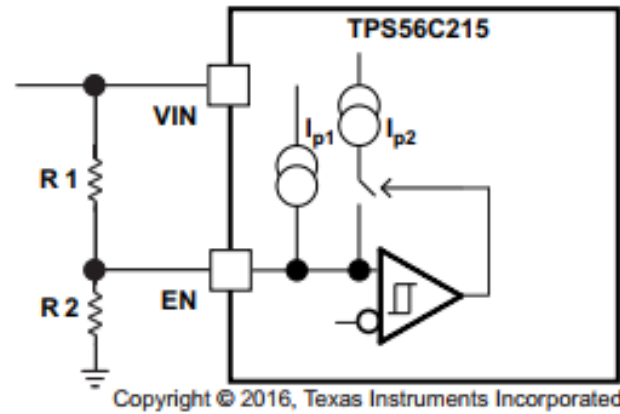
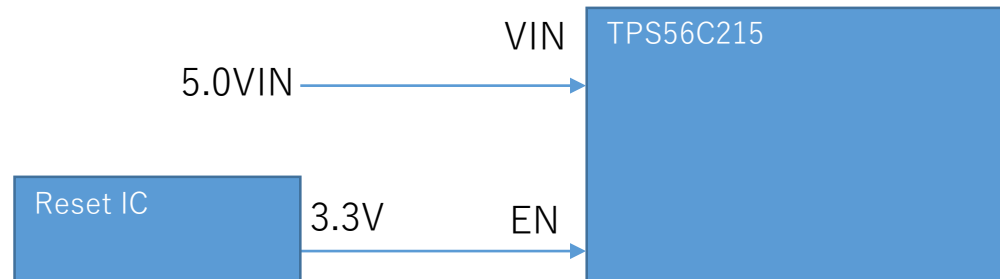
In the datasheet p.18,
Are I_{p1} and I_{p2} pull-up from V_{in} ?

Is it possible to input 3.3 V of CMOS to EN pin
without using dividing resistance between V_{in} to EN ?

And is it better to change the level by OpenDrain?
